W. Harrison Welch, PE Stonewall Structural Engineering, PLLC 9203 Baileywick Rd. #200 Raleigh, NC 27615 (919)407-8663

Re: Review of Proposed Floor Framing Repairs — 18 Pineridge Cove, Sanford, NC 27332

Detail 1 – Repair Plan (Provided by Tar Heel Basement Systems)

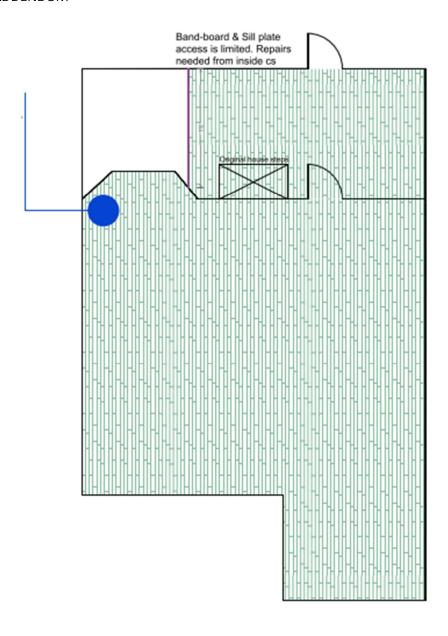
1. Replace the rim band and sill plate.

The uneven floors could be the result of out of level construction. Additionally, the sill plate should be anchored per the requirements of the 2018 edition of the *North Carolina Residential Building Code*.

Based on our review of the information provided, the proposed floor framing repairs are recommended to be installed as follows:

- 1. Remove the approximate 11' section of rim band at the area of uneven floors and replace with full depth treated 2x #2 Southern Yellow Pine (SYP) tight fit beneath the floor sheathing.
- 2. Remove the above-noted sections of sill plate at the uneven floors and replace using treated 2x # 2 SYP material and fasten with $\frac{1}{2}$ "Ø J-bolts at 6' on center max spacing and 12" from sill plate ends and breaks with at least (2) bolts installed per sill plate segment.
 - a. Bolts should be embedded at least 7" into the top course of the wall.
